31/07-05I 10009 Menlo Ave
Capitol View Historic District

CASE NO. A-6152

Memorandum**Date: September 5, 2006****To: Tania Tully, Historic Preservation Planner****From: Bill Karas****Info: Eric Gronning****Re: 1009 Menlo Avenue Variance Request****Case No. A-6152**VIA FAX

TO: Robert Hubbard, Director
FROM: Tania Tully, Senior Planner
Historic Preservation Section
SUBJECT: Historic Area Work Permit #397538

SITE SECTION

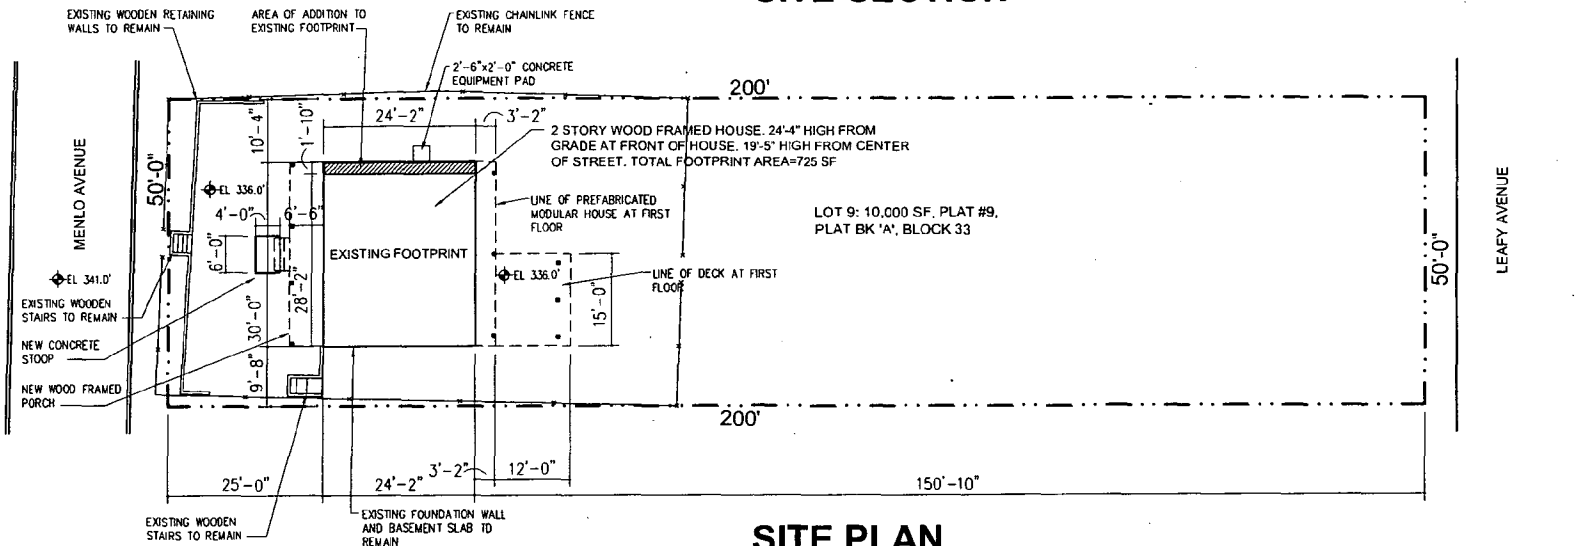
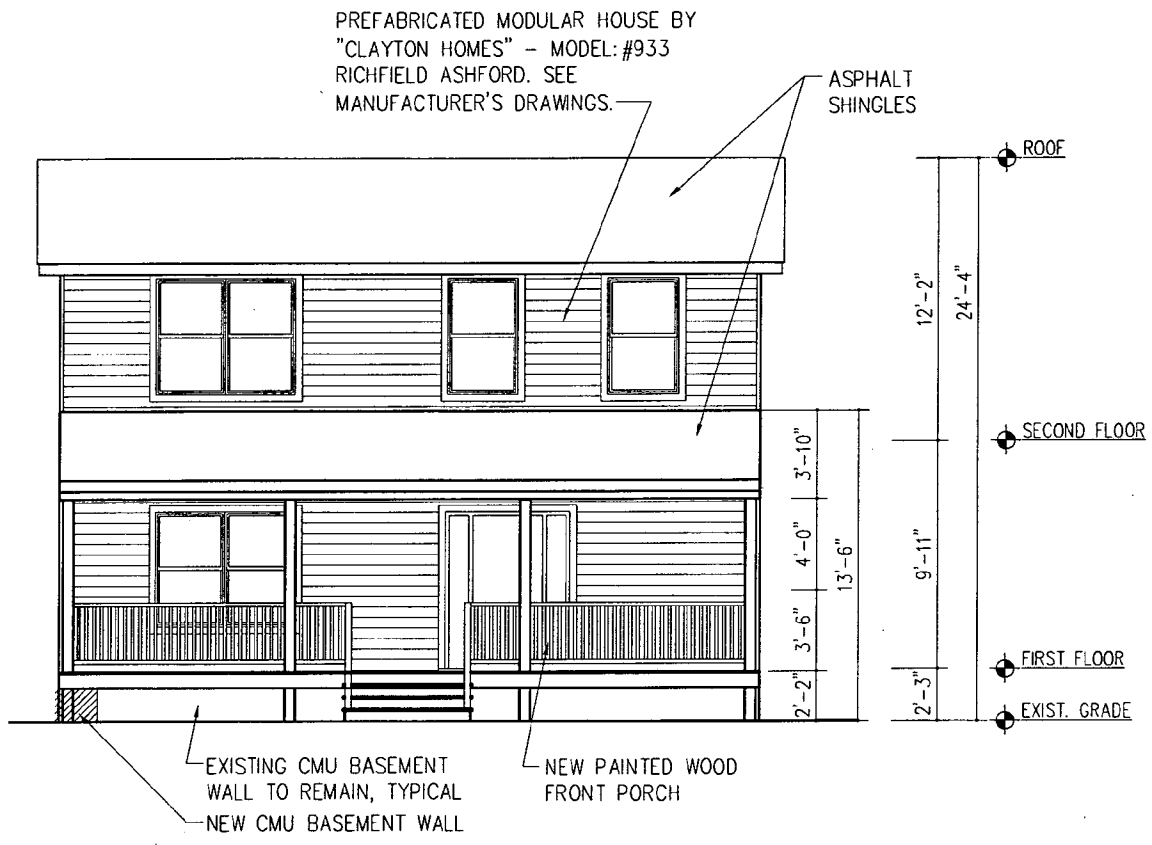
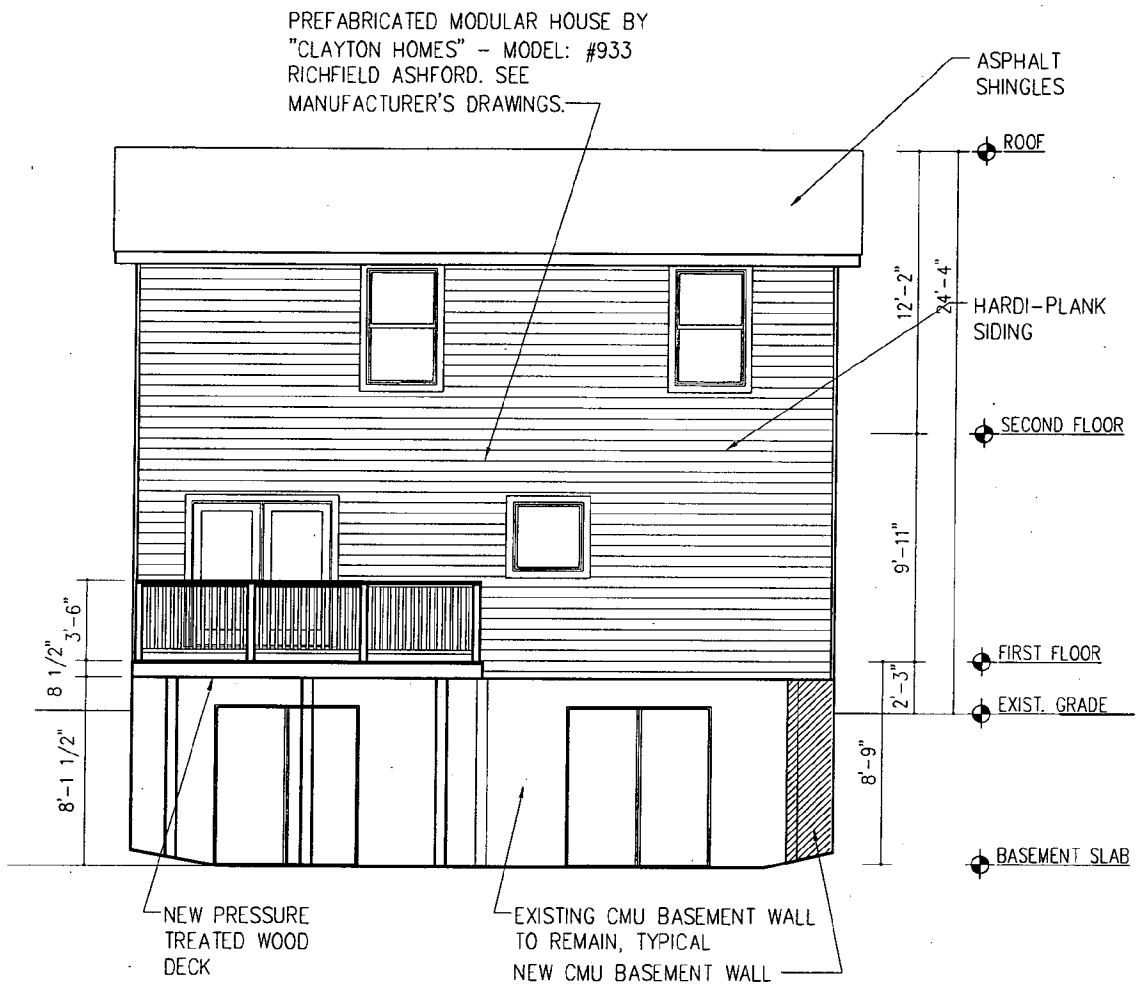
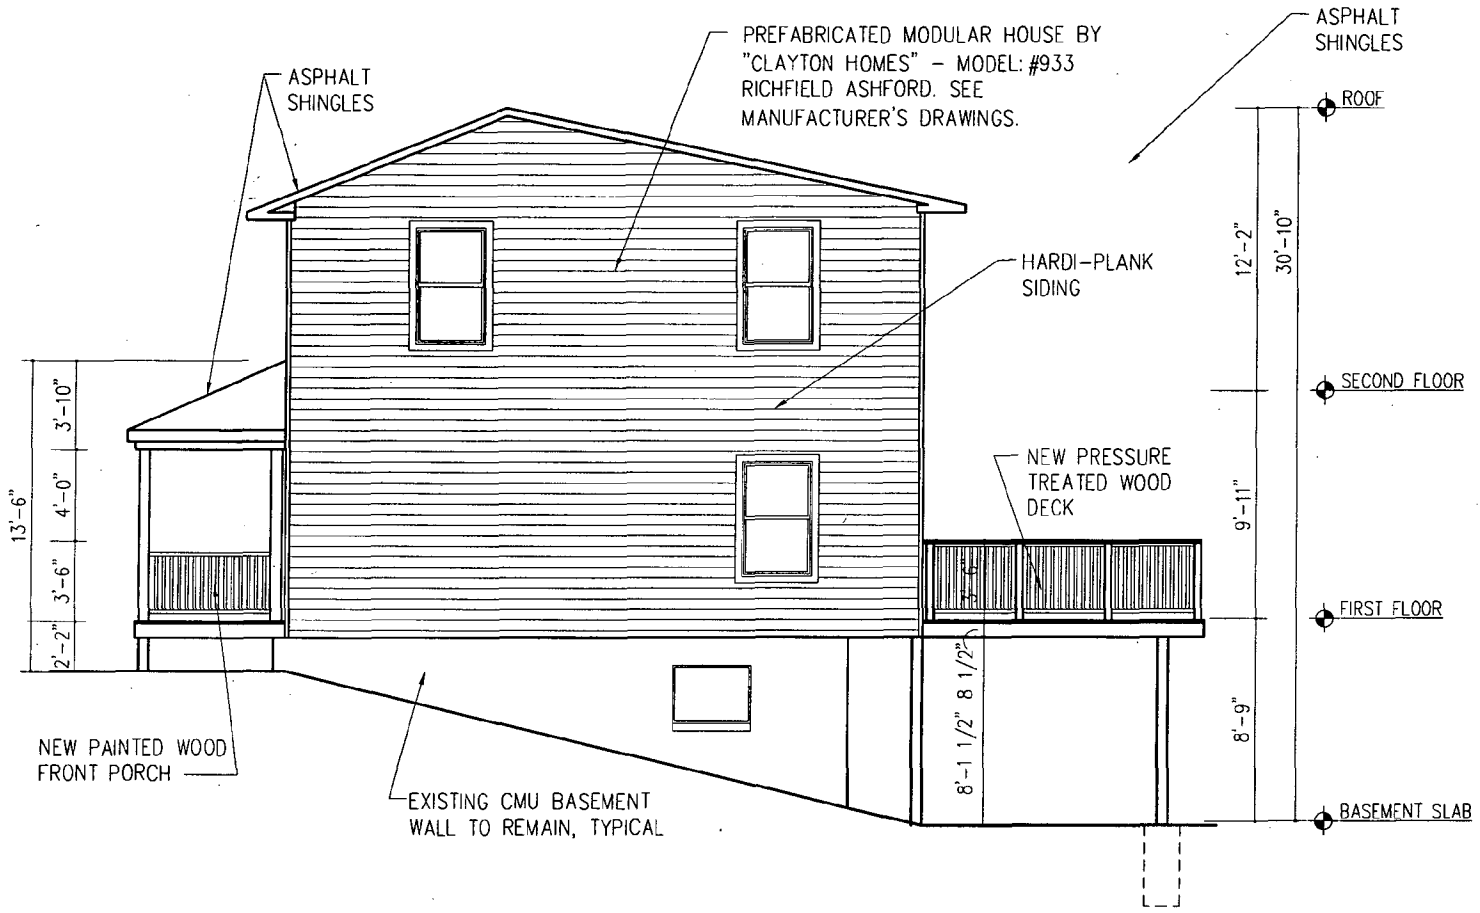
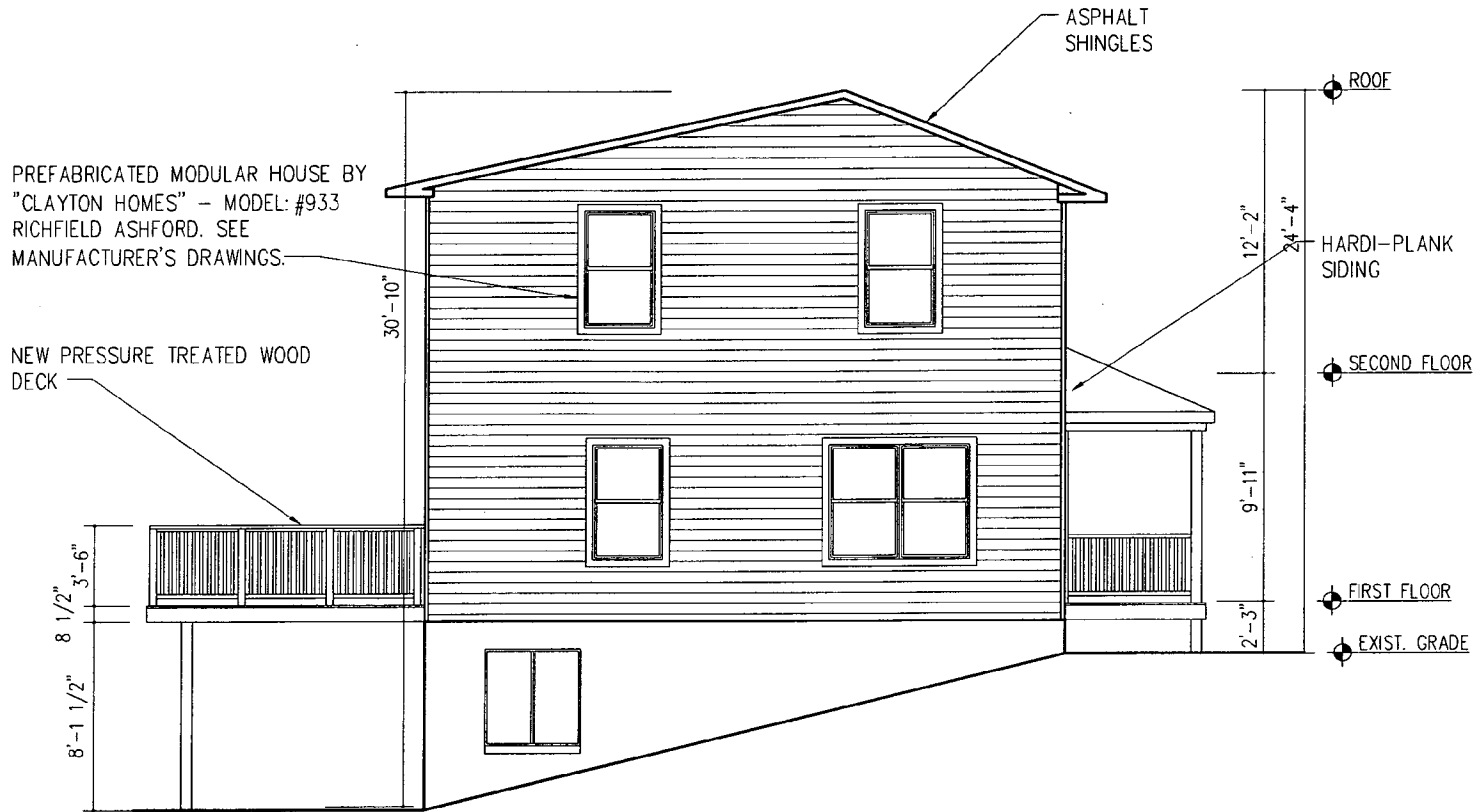
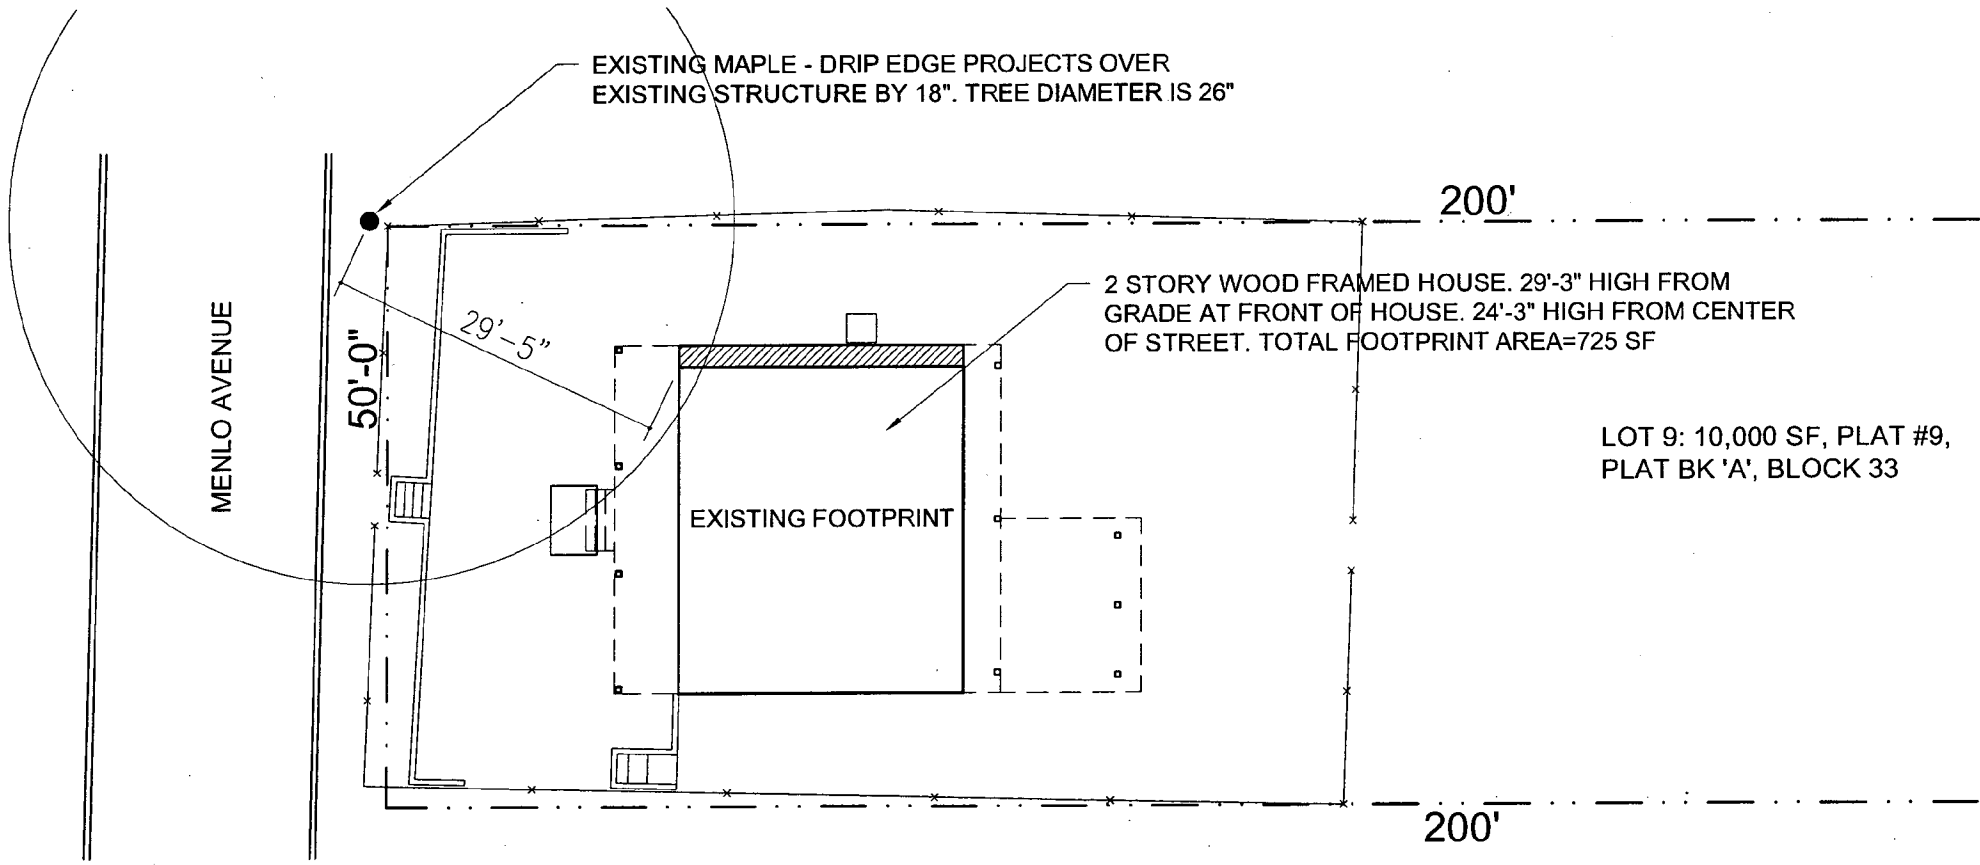
Per Commissioner Fuller's suggestion of a maximum building height of 25', we have lowered the height of the structure to 24'-4" above grade (originally it was 29'-3"). We have also made modifications to the roof and porch as indicated on the drawings. We have also added windows per the boards suggestion.

13 MR. FULLER: Just a quick question, maybe it's more appropriate for
14 the applicant. In looking at the elevations there seem to be what are shown
15 as the back elevations and then what shows as the existing back elevation
16 with a demolition plan sort of overlaid on it.

20 MS. TULLY: Oh, I think, yes. That, yeah, it's a labeled
21 incorrectly. I see what you're talking about. Like Circle 14 that's exactly
22 a side, not a rear. Actually it looks you might just be able to flip 14 and
23 15 or what they're label drawing 6 and 7. Number 6 is actually a side and
24 number 7 is actually a rear.

TITLE:
SITE SURVEY & ESTABLISHED BUILDING LINE

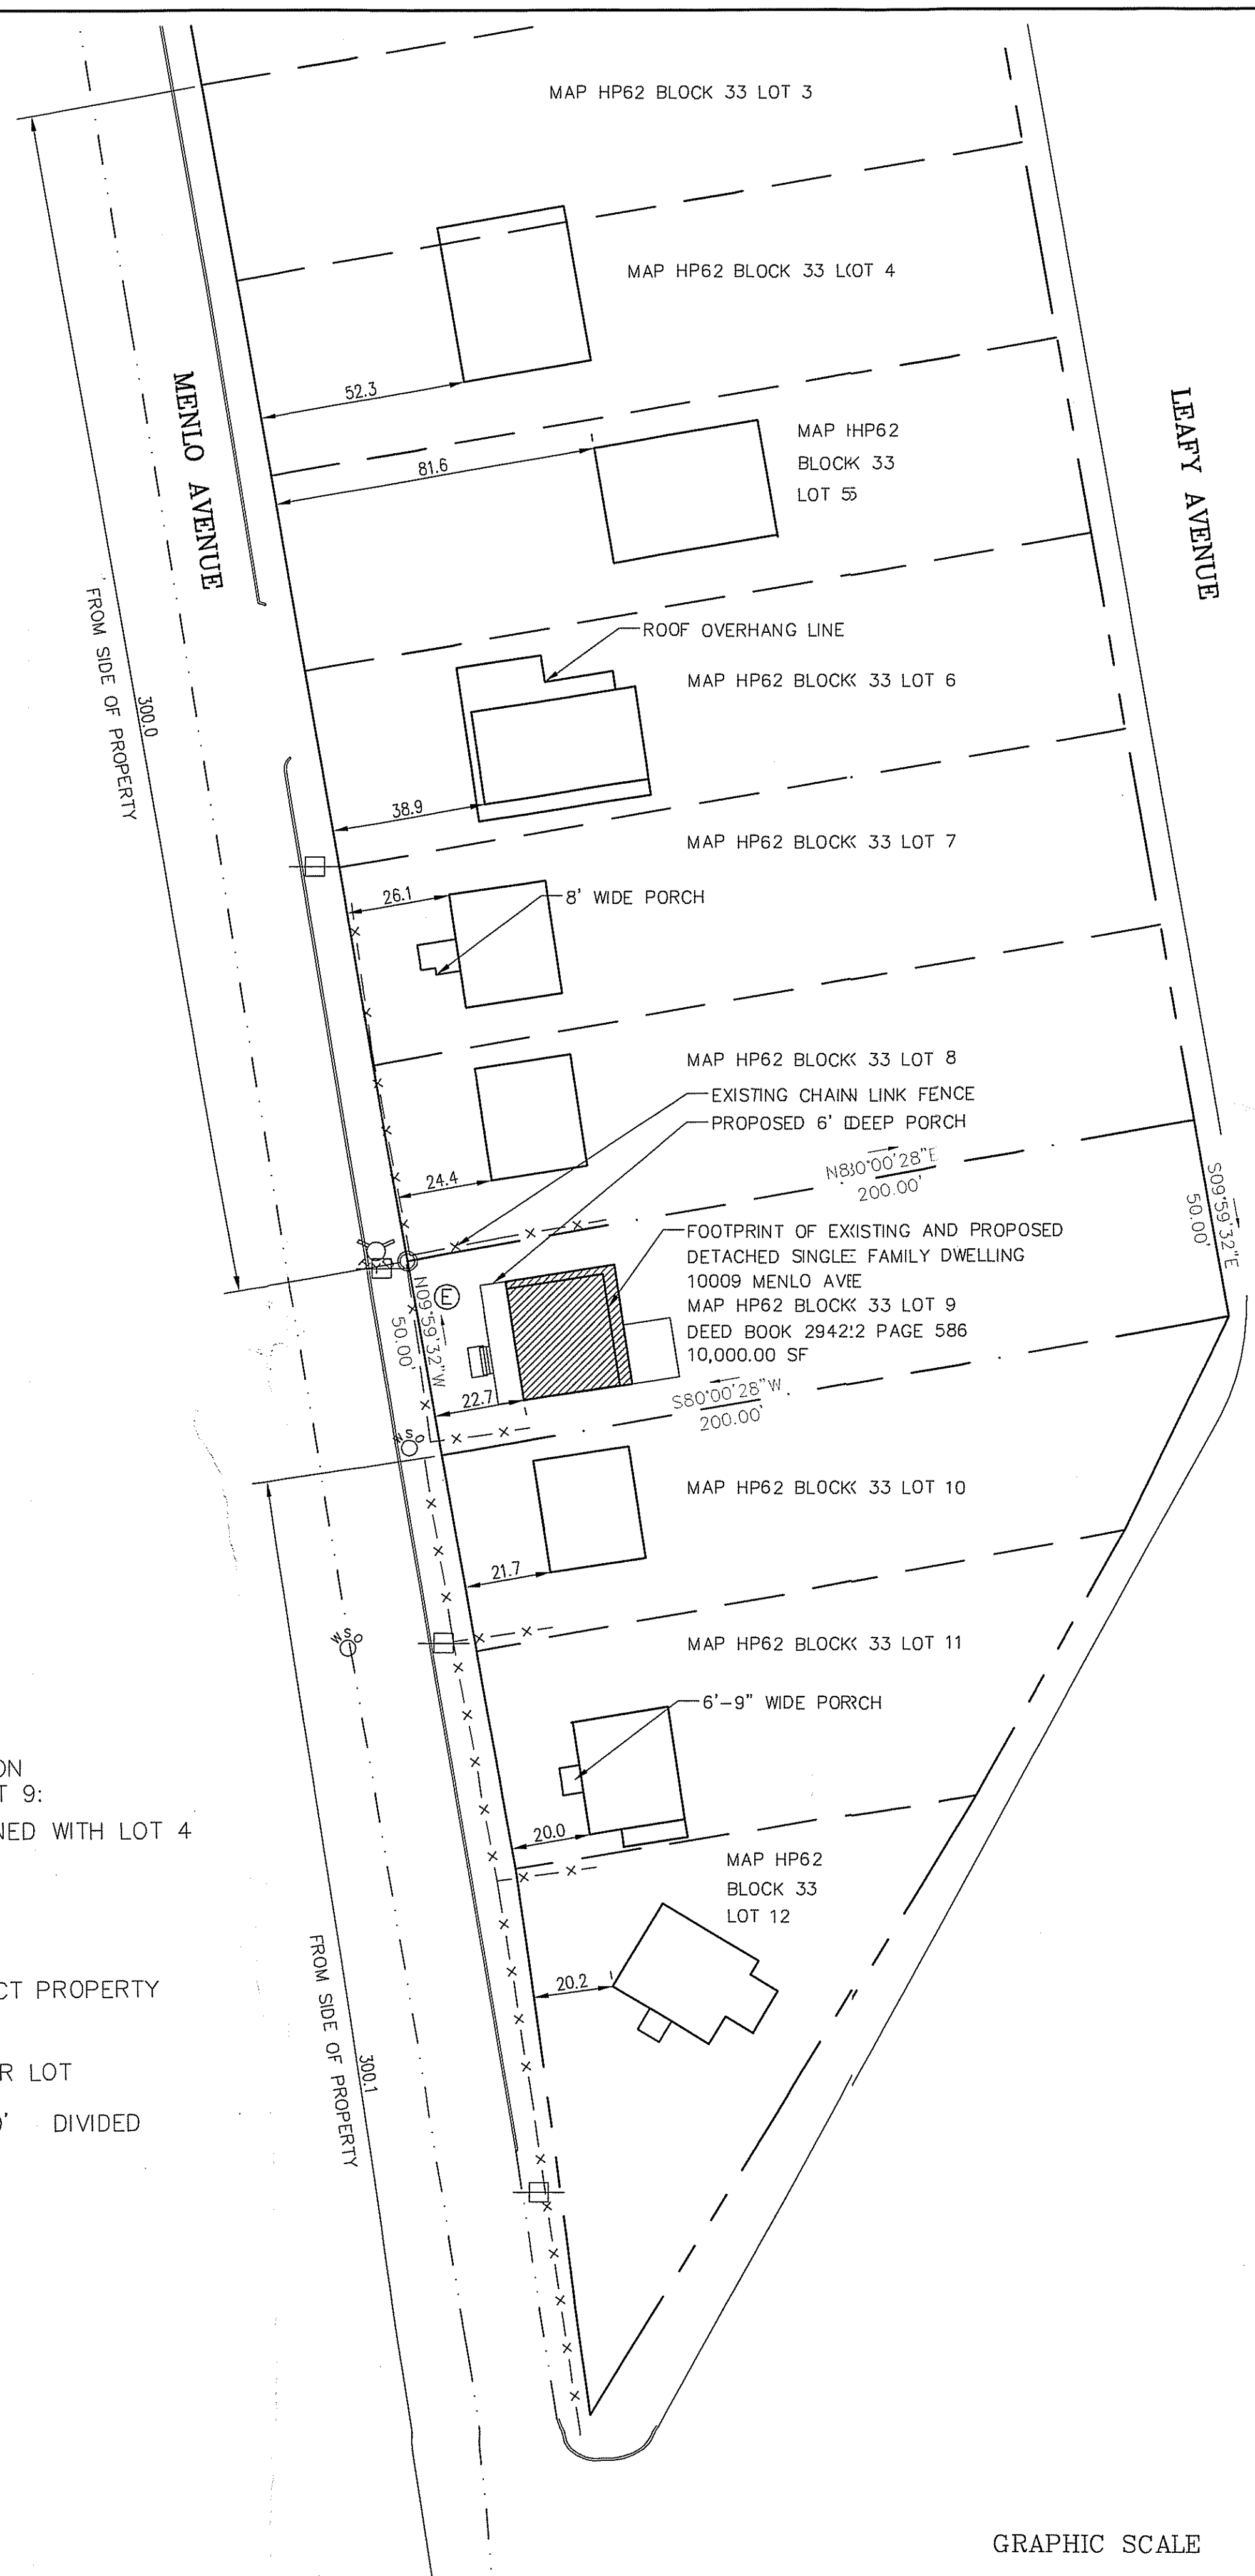
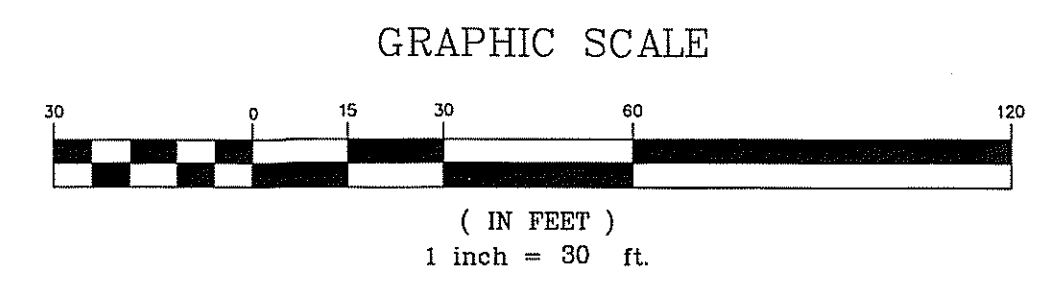
The proposed construction of a new single-family dwelling requires a 24.70 foot variance as it is within twenty-five (25) feet of the established front building line. The required established building line is 49.70 feet, in accordance with Sections 59-C-1.323(a) and 59-A-5.33.

We are seeking a variance from the Front Established Building Line (EBL) setback requirement.

The Historic Preservation Commission has approved, and will only approve, a new residence if it is located at 25' from the front property line. A 25' front setback is in compliance for this R-60 zoned property. This location is also in keeping with the existing adjacent residences which are located at 21.7' and 24.4' from the front property line.
